MAINE TURNPIKE AUTHORITY

ADDENDUM NO. 1

CONTRACT 2019.04

INTERCHANGE 103 BARRIER TOLL PLAZA
OPEN ROAD TOLLING CONVERSION
MILE 103.00

SHEET NUMBER: MOT2-02

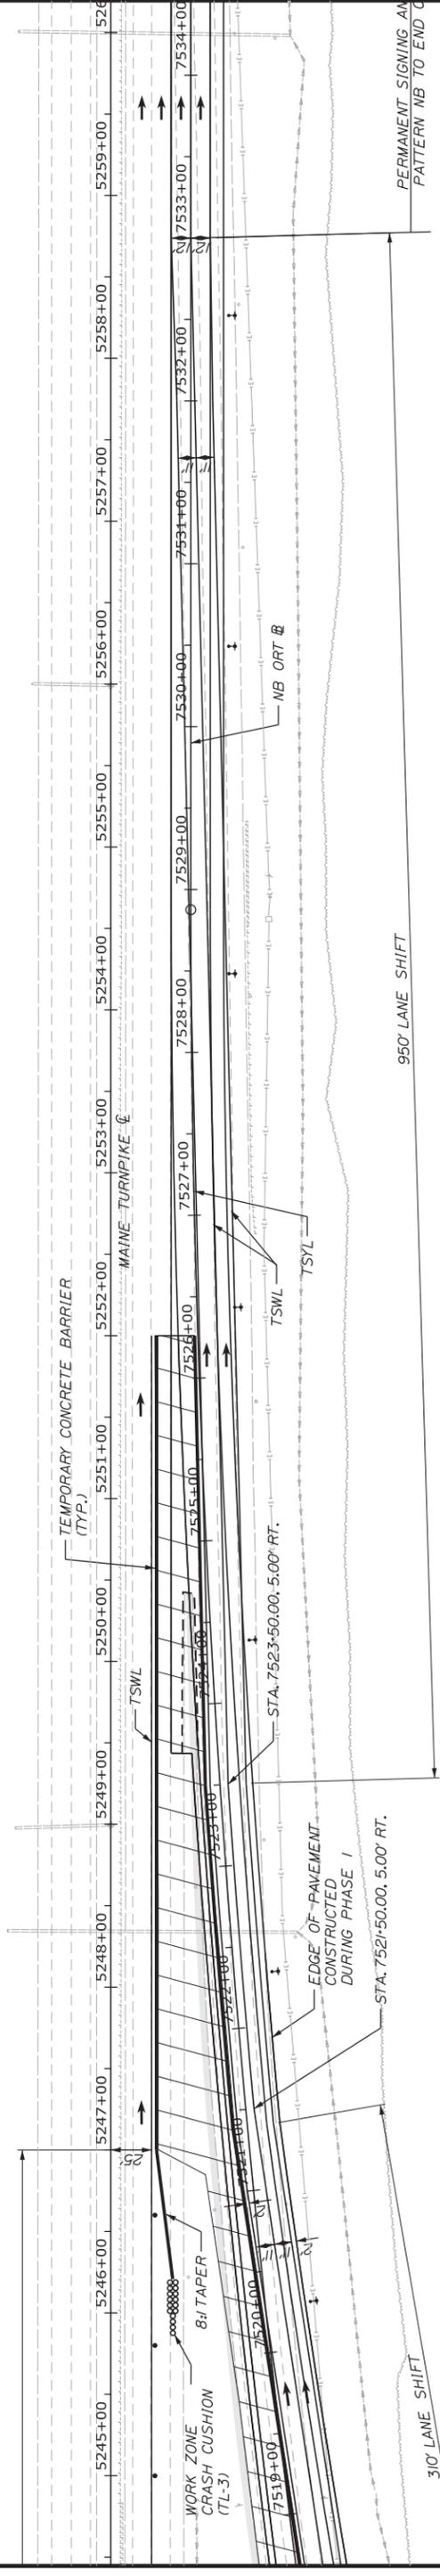
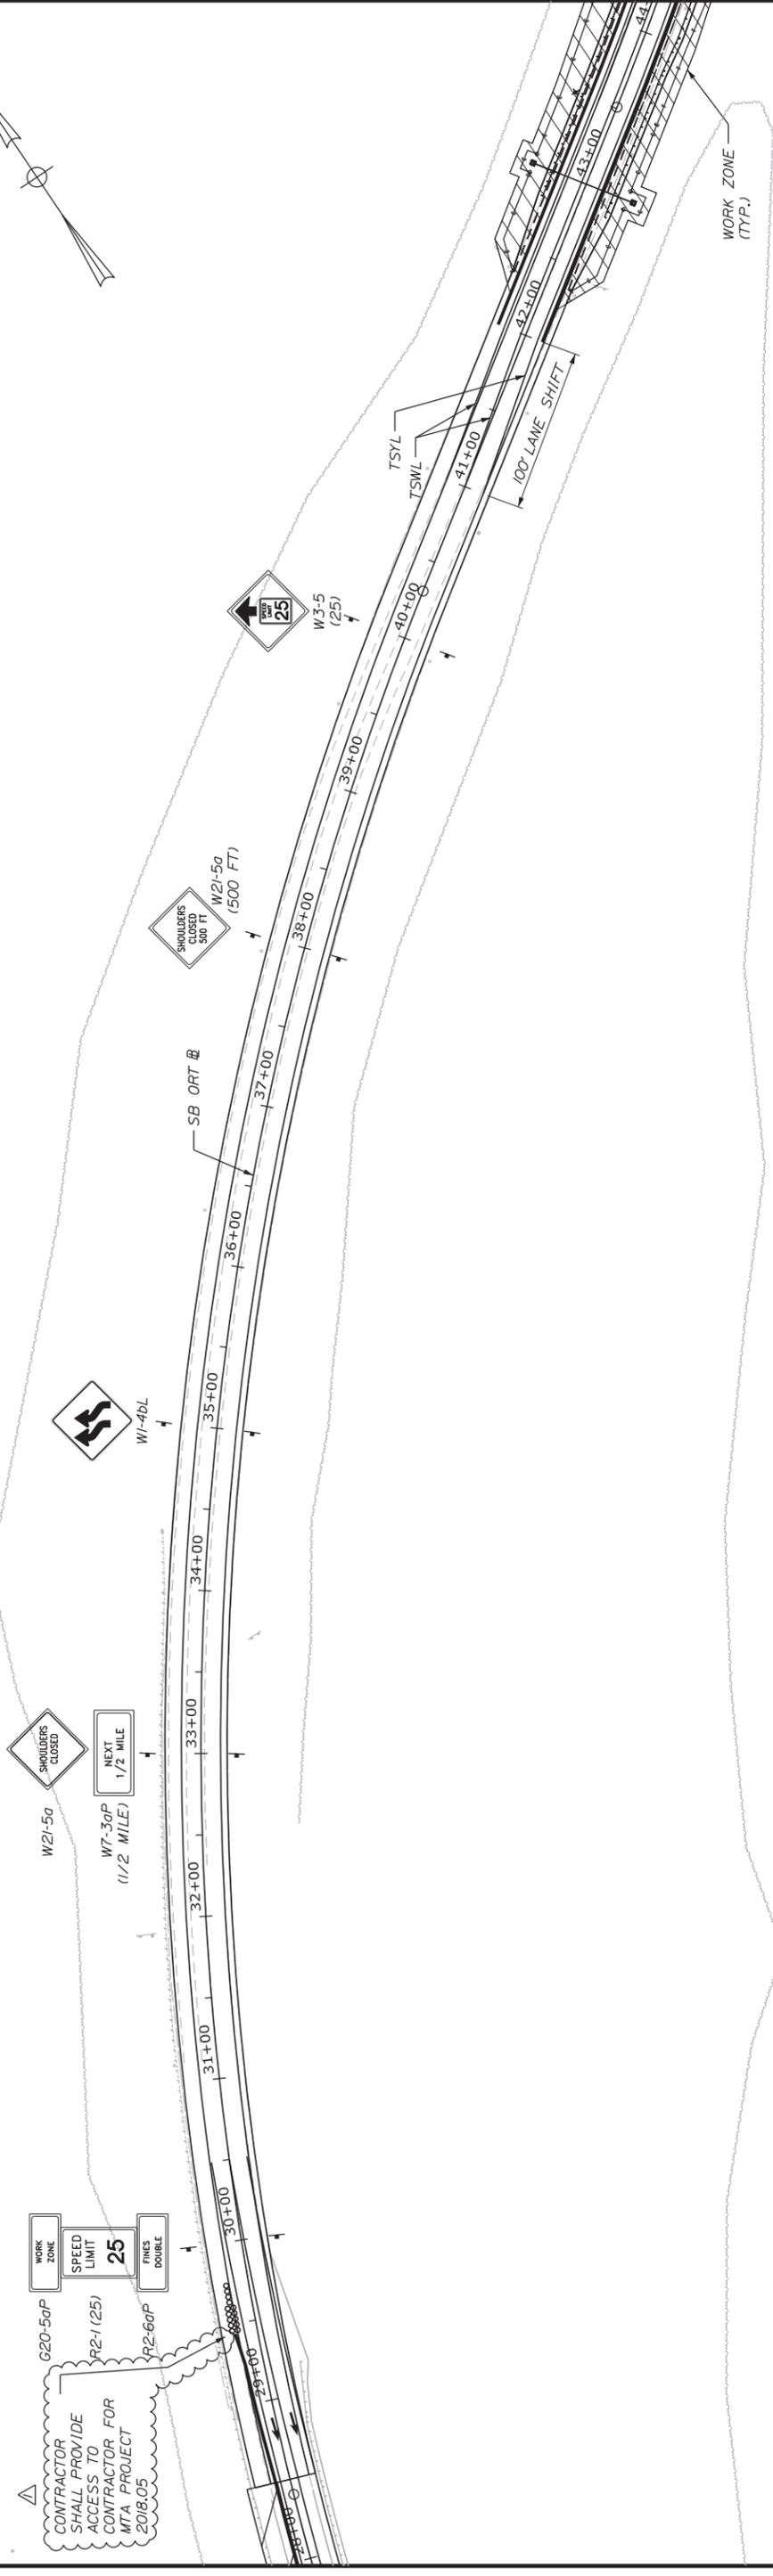
Answer: This addendum will revise Plan sheets 32 and 33 of 503 to address contractor access for project 2018.08.

WORK ZONE
 SPEED LIMIT 25
 FINES DOUBLE
 G20-5aP
 R2-1 (25)
 R2-6aP
 CONTRACTOR SHALL PROVIDE ACCESS TO CONTRACTOR FOR MTA PROJECT 2018.05

No.	Revision	By	Date
1	ADDED NOTE	EJB	4/19

INTERCHANGE 103
 ORT CONVERSION
 PHASE 3
 MAINTENANCE OF TRAFFIC PLAN 2

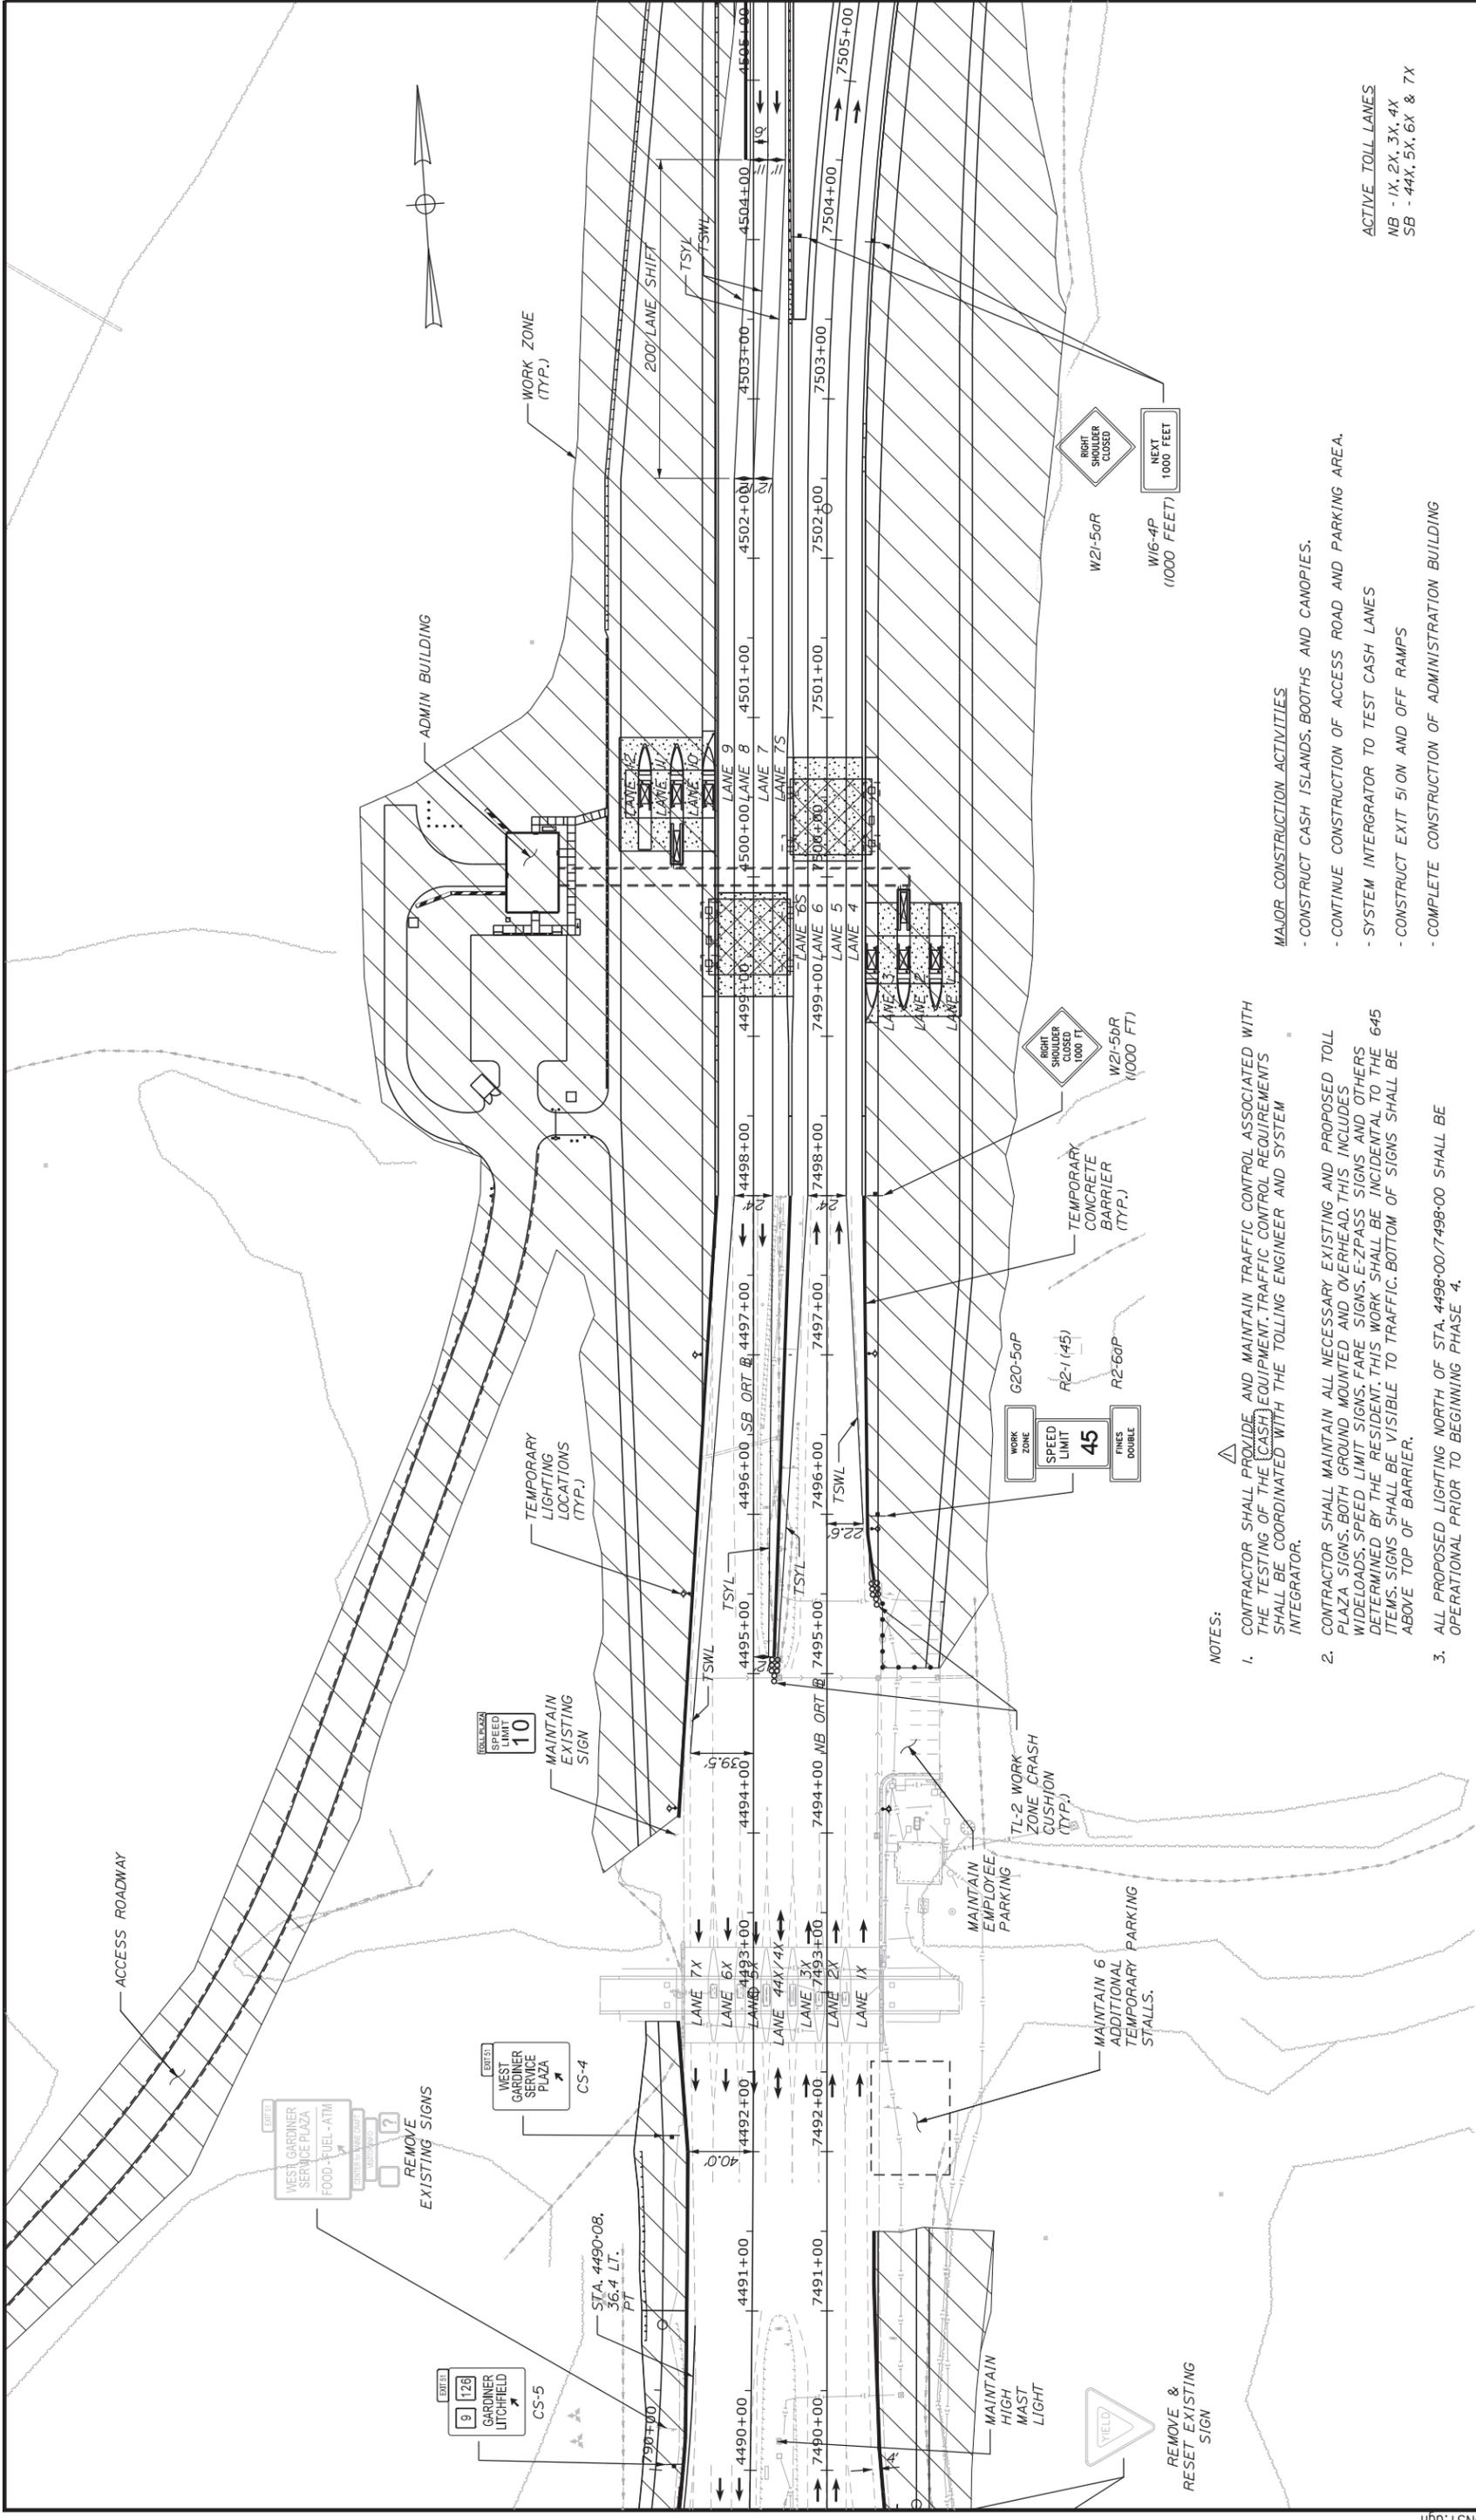
Answer: This addendum will revise Note 1 on Plan sheet 46 of 503.

- NOTES:**
- CONTRACTOR SHALL PROVIDE AND MAINTAIN TRAFFIC CONTROL ASSOCIATED WITH THE TESTING OF THE CASH EQUIPMENT. TRAFFIC CONTROL REQUIREMENTS SHALL BE COORDINATED WITH THE TOLLING ENGINEER AND SYSTEM INTEGRATOR.
 - CONTRACTOR SHALL MAINTAIN ALL NECESSARY EXISTING AND PROPOSED TOLL PLAZA SIGNS, BOTH GROUND MOUNTED AND OVERHEAD. THIS INCLUDES WIDELOADS, SPEED LIMIT SIGNS, FARE SIGNS, E-ZPASS SIGNS AND OTHERS DETERMINED BY THE RESIDENT. THIS WORK SHALL BE INCIDENTAL TO THE 645 ITEMS. SIGNS SHALL BE VISIBLE TO TRAFFIC. BOTTOM OF SIGNS SHALL BE ABOVE TOP OF BARRIER.
 - ALL PROPOSED LIGHTING NORTH OF STA. 4498+00/7498+00 SHALL BE OPERATIONAL PRIOR TO BEGINNING PHASE 4.

No.	Revision	By	Date
1	REVISED NOTE 1	EJB	4/19
